## CALIFORNIA COASTAL COMMISSION

**W18C**

SUBJECT: CITY of CARPINTERIA, LOCAL COASTAL PROGRAM  
MAJOR AMENDMENT NO. 1-95, to incorporate into the certified LCP the  
Carpinteria Bluffs Coastal Access, Recreation, and Open Space Master Program,  
a component of the LCP Implementation Plan. The Master Program will replace  
those portions of the City's certified Coastal Recreation and Access  
Implementation Plan applicable to the Carpinteria Bluffs only.

STAFF RECOMMENDATION: Certification if Modified as Suggested

7/26/95(CCP403) Figure 6

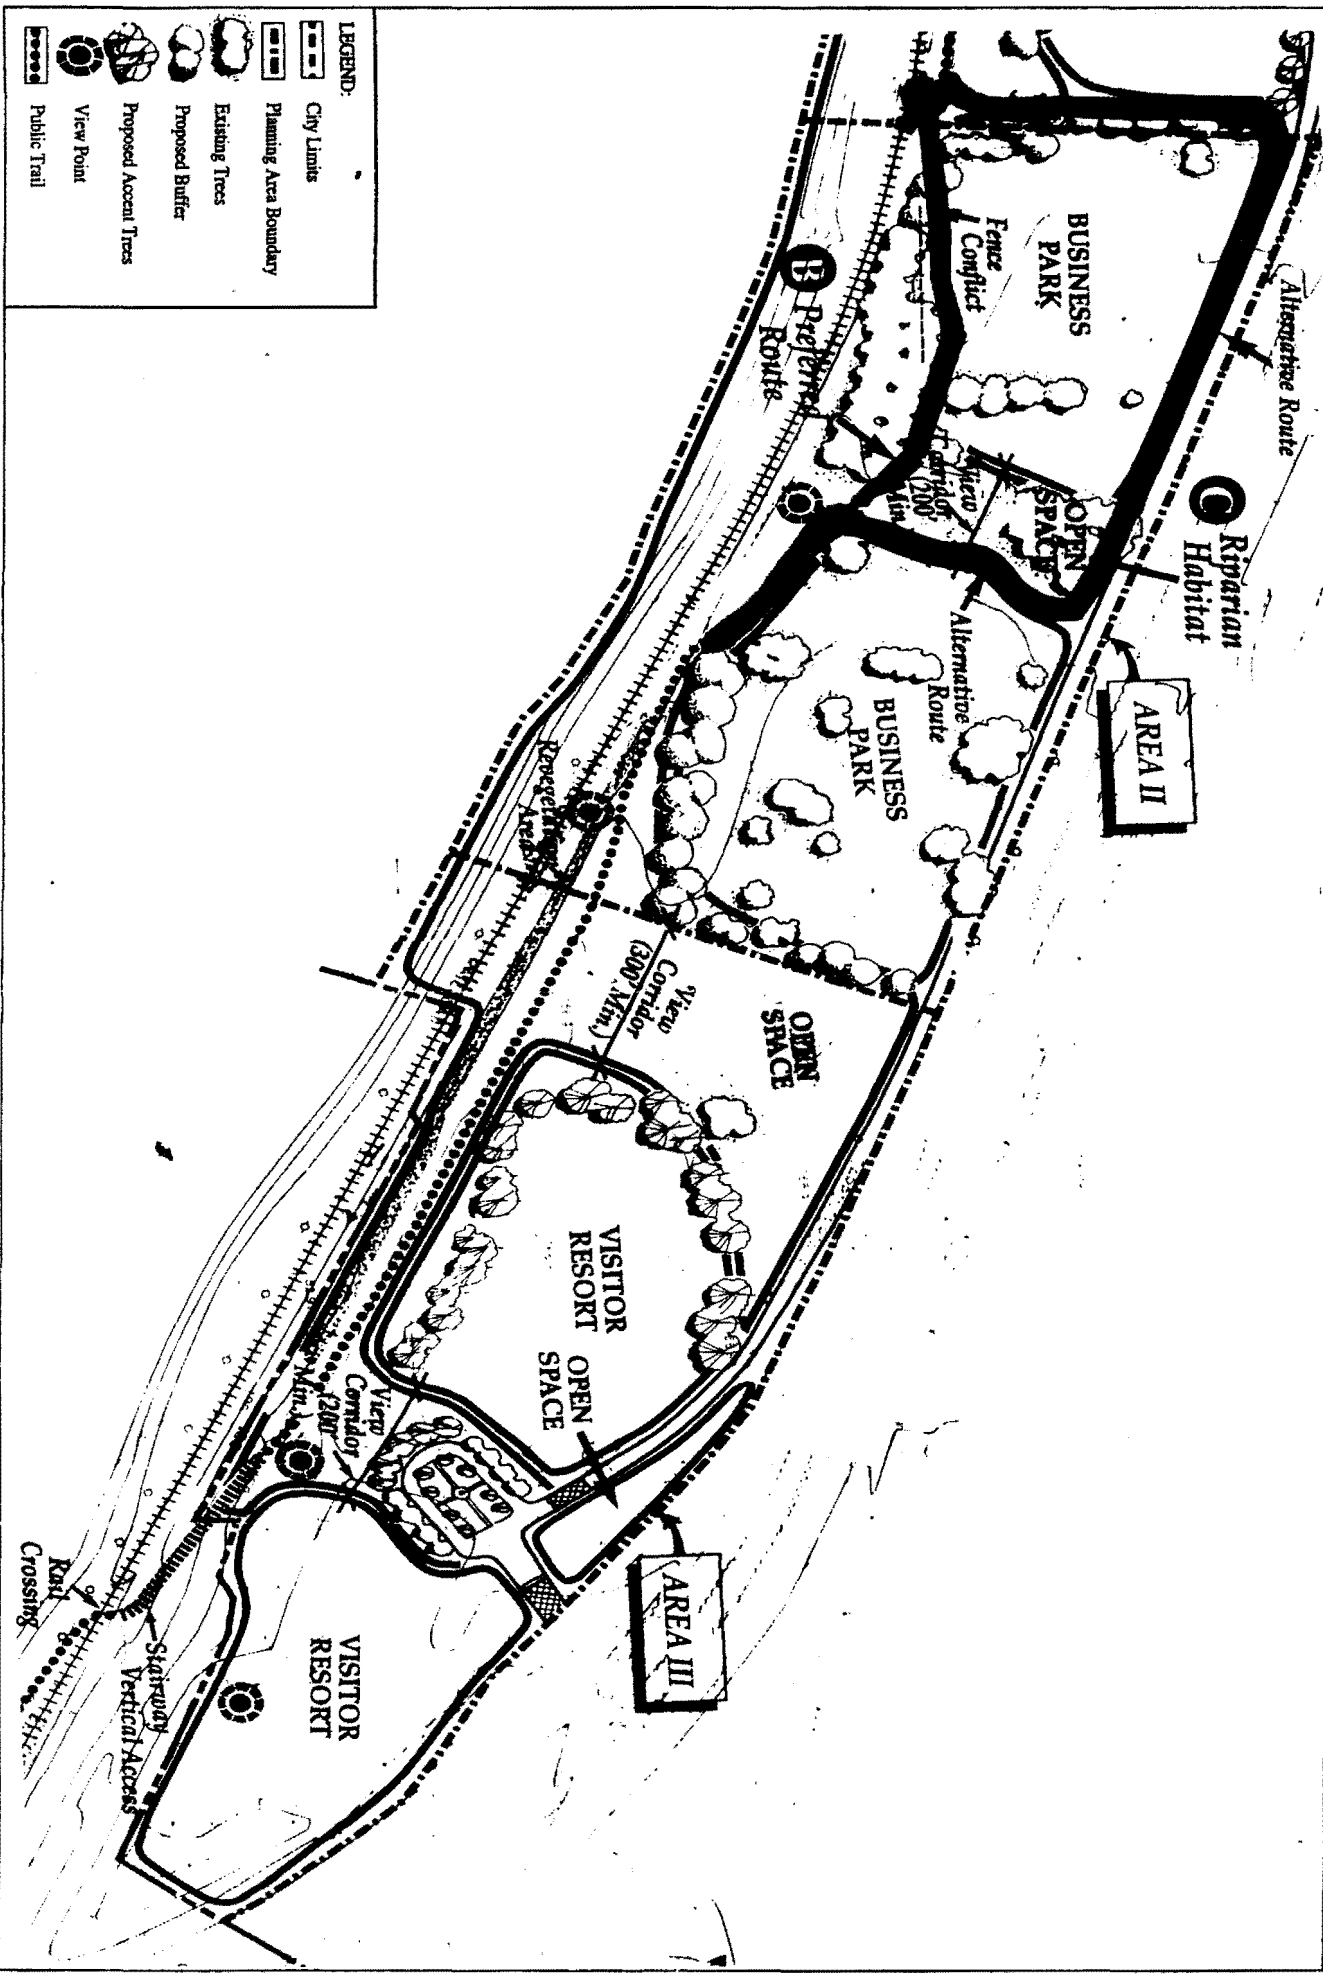
8. A blufftop trail shall be developed along the preferred alignment illustrated in Figure 6. The horizontal portion of the alternative alignment shown on Figure 6, along Carpinteria Avenue, shall be constructed only if the City of Carpinteria fails to obtain the necessary easements to construct the preferred alignment. Dedication of easements to construct the alternative alignment shall be required of all development proposals through which the alternative alignment passes until or unless the preferred railway has been constructed and opened for public use.

12. A blufftop trail with a minimum width of 20 feet shall be developed along the alignment illustrated in Figure 6.

13. Provisions for public parking for shoreline users shall be made within the southerly extension of the alignment of State Route 150 as illustrated in Figure 6. In addition, provisions for parking for shoreline users shall be made within the visitor resort. A minimum of fifteen (15) parking spaces shall be provided adjacent to the designated view-oriented park, including a minimum of two (2) handicapped access parking spaces. No fees shall be charged for the public use of these parking spaces. A minimum of ten (10) public access parking spaces shall be provided at no charge within the upper tier resort parking area adjacent to the easternmost designated view point in Bluffs Area III. At least one of these shall be designated for handicapped access parking. Coastal Access parking spaces shall be provided in addition to such other requirements for the provision of parking that may be imposed upon the development. Upper tier public access parking shall be connected to the designated public view point by a

14. An open space access corridor connecting Carpinteria Avenue with the bluffs trail and park shall be provided in conjunction with trail development along the southerly extension of the State Route 150 interchange with U.S. 101 as illustrated in Figure 6. The access corridor shall contain a connector trail to the main blufftop trailway, park and vista point and shall be constructed to Americans With Disability Act standards. The open space access corridor shall be landscaped exclusively with locally-native, coastal bluff scrub species. Lighting in the access corridor shall be restricted to the connector trail, shall be shielded from nearby sensitive habitat areas, shall be directed downward, and shall be minimized to be less than 0.01 foot-candles at a distance of five feet from the trail; otherwise, lighting shall not be permitted in the access corridor. Non-pedestrian use of the open space access corridor shall be strictly limited to the connector trail and warning signage shall be posted.

16. A second vista point, including benches, trash receptacles, and bicycle racks, shall be provided in the upper portion of Area III along the bluff edge overlooking the ocean. Although illustrated in Figure 6, the specific location of this vista point will be determined during the site plan review process for Area III. The final selection of a vista point shall be determined on the basis of providing optimal public access to the expansive coastal vistas available at this location. Benches and other amenities shall be accessible via a connector trail to the coastal access parking required within the resort pursuant to Implementation Measure 13. The connector trail between the parking area and the vista point shall be designed to Americans With Disability Act standards. It is intended that this easterly vista point be privately developed and maintained as part of the adjacent visitor-serving resort, but that it remain accessible to the public.

Figure 8

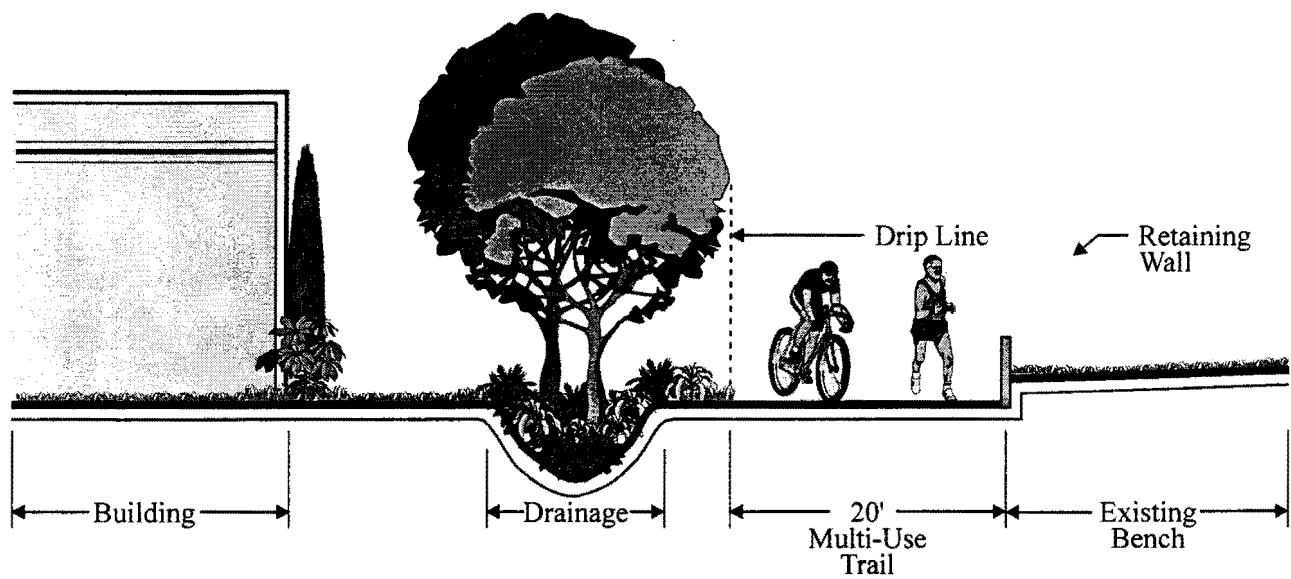
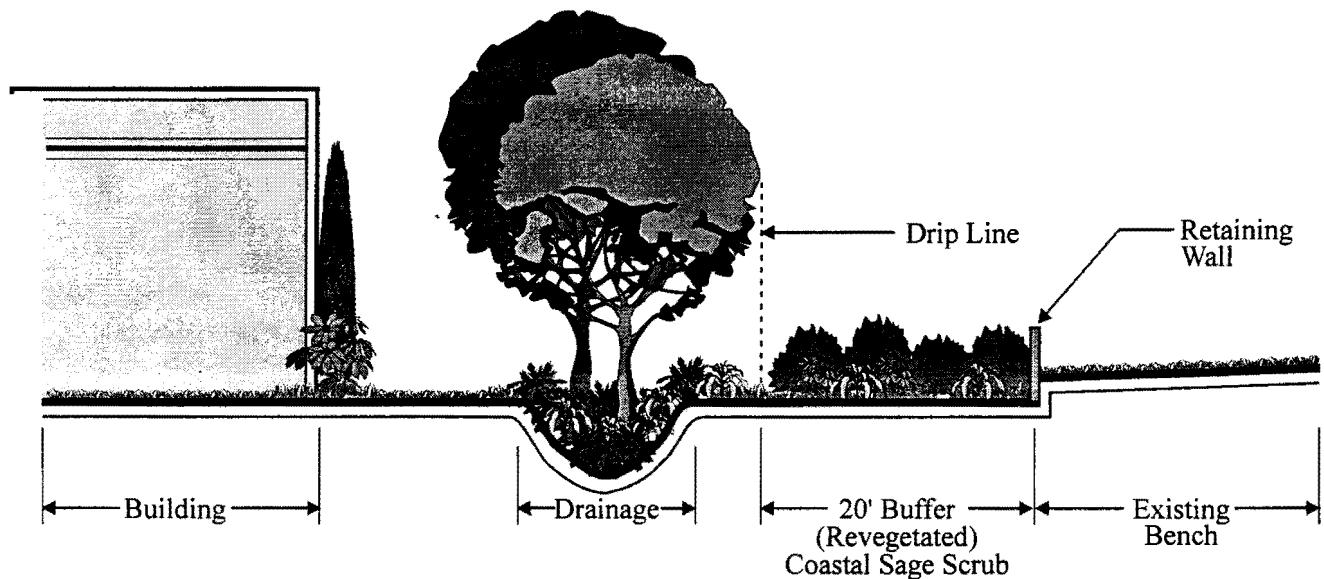
- The trail shall have a minimum width of 20 feet except for the alternative alignment along the east edge of the riparian corridor, where the trail shall have a minimum width of 12 feet (Figure 7). ~~The trail adjacent to the riparian corridor would function as a vertical access if the bluff top trail is constructed concurrent with construction of Line K.~~ The trail adjacent to the riparian corridor shall be deleted from the Master Program if the preferred route is constructed, and the
